CATEGORY: MISC SYSTEM/ITEM: COVER ASSEMBLY, MG  
TO CONTRACT/PR: E30SSXX3

13. TITLE OF CHANGE <b>MARKING OF RAIL SLOTS</b>				14. CONTRACT NO. AND LINE ITEM <b>DAAE20-96-E-0326</b> <b>DAAE20-99-D-0100</b>			
				15. PROCURING CONTRACTING OFFICER

9. TITLE OF DOCUMENT

b. DEVELOPMENT							<b>12</b>
c. PRODUCT							
13. TITLE OF CHANGE <b>MODIFICATION OF RAIL MARKINGS</b>							
14. CONTRACT NO. AND LINE ITEM <b>DAAE20-96-E-0326</b> <b>DAAE20-99-D-0100</b>				15. PROCURING CONTRACTING OFFICER

VIEW U-U

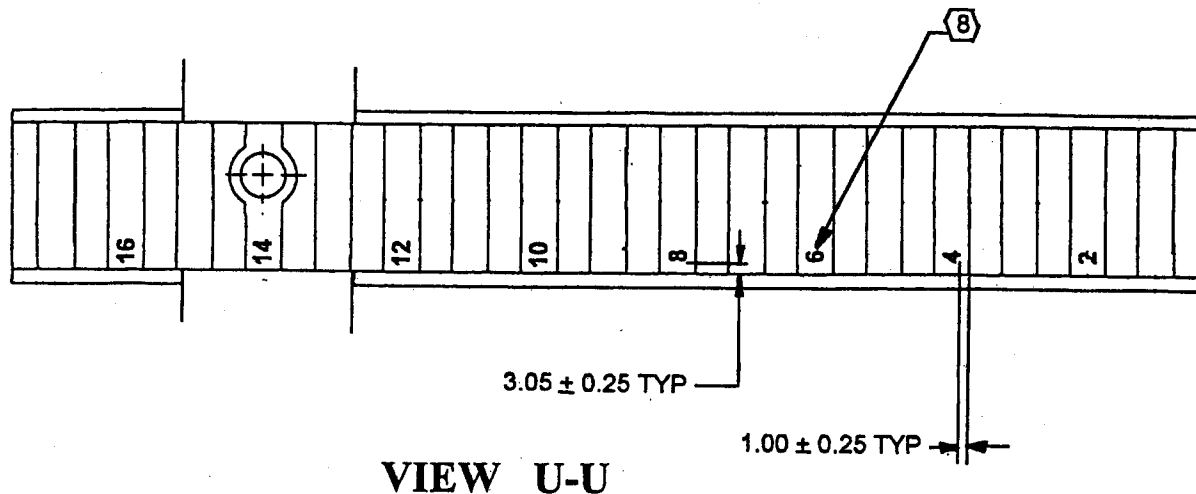
13. DESCRIPTION OF CHANGE:

**ADD: NOTE 8:**

" 8 INSCRIBE NUMERALS 3.00 +0.25 HIGH, 0.25 + 0.25 DEEP X 0.50 +0.25 WIDE. NUMERALS SHALL BE FILLED USING FILLER, FINISH 30.1.1 OR 30.1.2 OF MIL-STD-171, COLOR WHITE."

ON SHEET 5: VIEW U-U:

**CHANGE: ON SHEET 2: IN ZONES B-4 THROUGH C-6:**

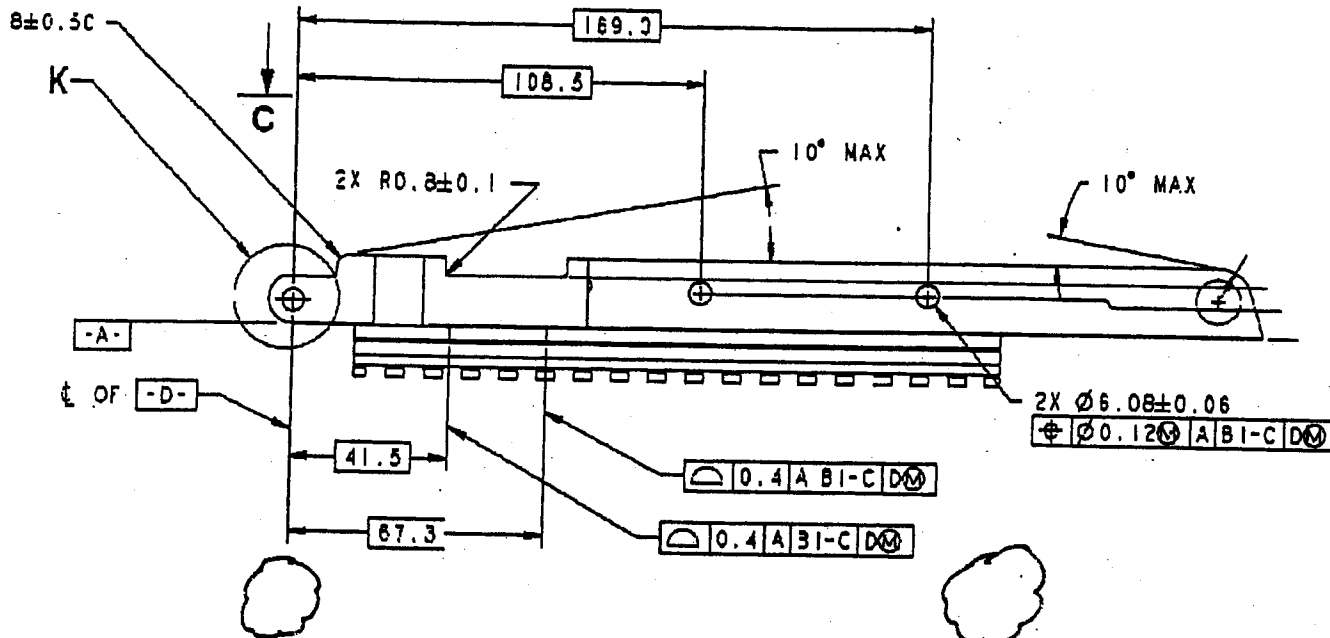
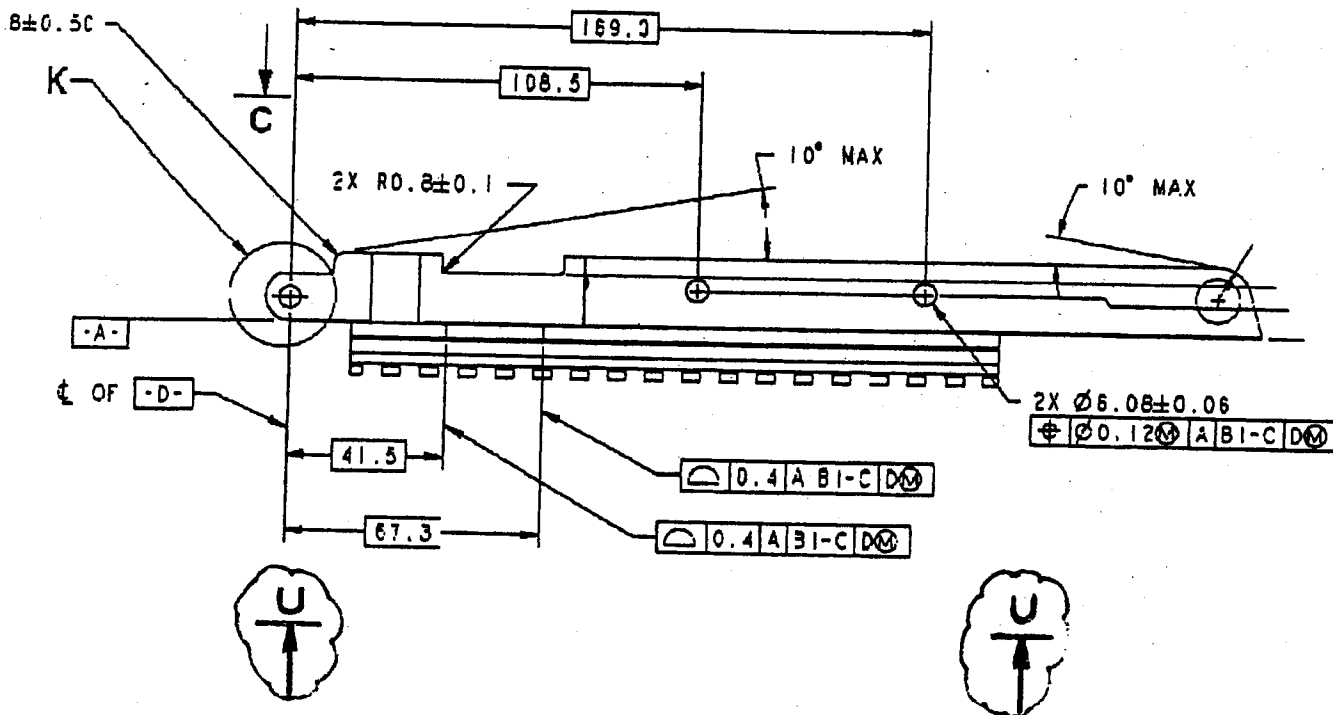
## DESCRIPTION OF REVISION:

FROM:

TO:

**CHANGE: ON SHEET 5: IN VIEW U - U:**

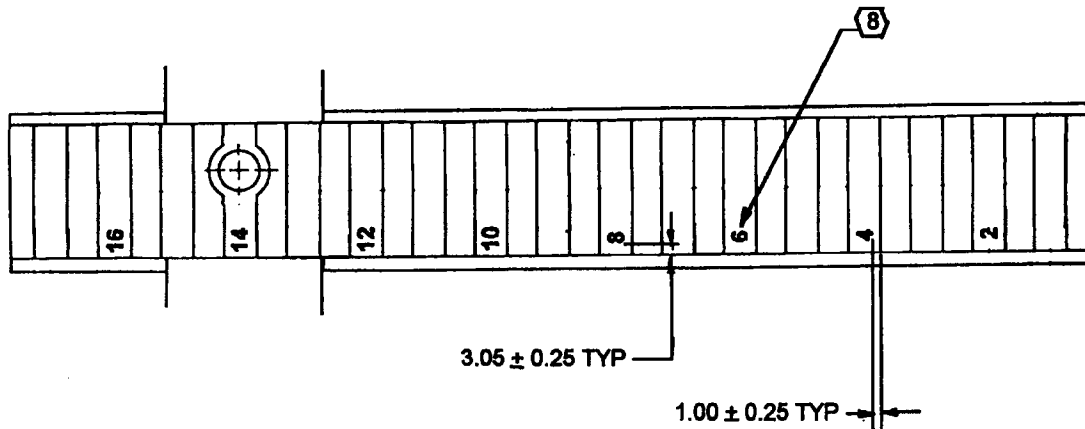
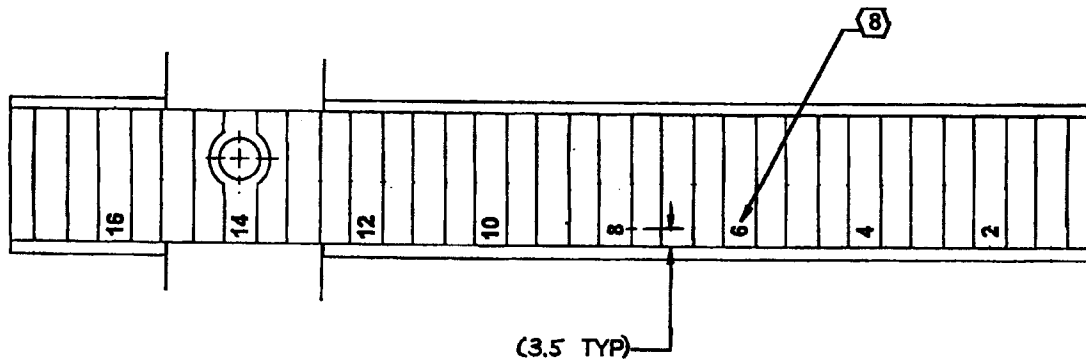
12. CONFIGURATION ITEM (OR SYSTEM) TO WHICH ECP APPLIES  <b>MACHINE GUN, 5.56MM; M249</b>		<b>NOR SH. 1</b> <b>OF 2</b>		<b>01SAW-018</b>	
13. DESCRIPTION OF CHANGE:  <b>THE DESCRIBED CHANGES APPLY TO REVISION B, SUPPLEMENTED BY THE FOLLOWING APPROVED NORs:</b>  <b>LOS2037</b>  <b>CHANGE:</b> <b>NOTE 8:</b>  <b>FROM:</b>  ⌞8⌟ INSCRIBE NUMERALS 3.00 + 0.25 HIGH, 0.25 + 0.25 DEEP X 0.50 + 0.25 WIDE. NUMERALS SHALL BE FILLED USING FILLER, FINISH 30.1.1 OR 30.1.2 OF MIL-STD-171, COLOR WHITE."  <b>TO:</b>  ⌞8⌟ LASER ENGRAVE NUMERALS 3.2 APPROX. HIGH X 0.025 MAX DEEP PER MIL-STD-130 CENTERED IN SLOTS AS SHOWN."

**DESCRIPTION OF REVISION:**

**FROM:**

**TO:**
